This Service Bulletin is a supplement to Service Manual, Group 41, Hydraulically Actuated Clutch (including transmission removal) VNL, VNM. Publication No. PV776-TSP24581/1.

Hydraulically Actuated Clutch (including transmission removal) VNL, VNM

Hydraulic Clutch Slave Cylinder

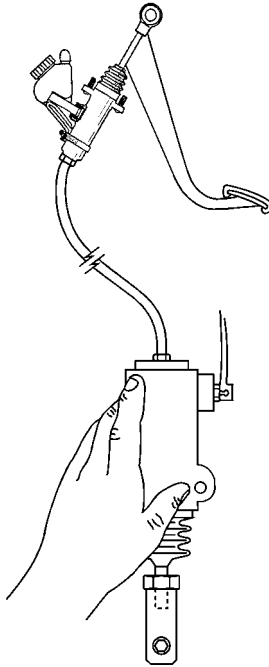
A = 23 mm (non-adjustable)

Please note, on page 6 of Specifications, that with Fuller or Rockwell transmissions the engagement of the output shaft inside of the clevis is 23 mm, this is not to be changed for any reason.

Note: Engagement is measured from the bottom of the clevis. Do not include the jam nut in this measurement.

W4001306

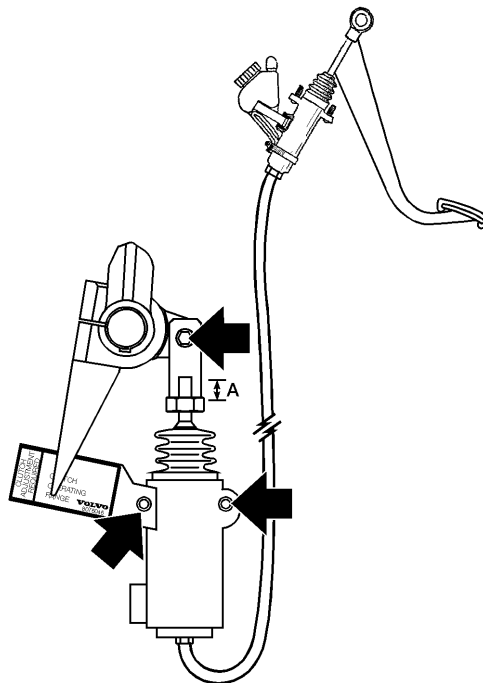
Volvo recommends holding the clutch slave cylinder vertically with the clevis pointing downward during bleeding to insure that all air is removed from the system. Please note on page 29 (step 7) in the "Master Cylinder Installation" service procedure and on page 32 (step 5) "Clutch Slave Cylinder Installation".
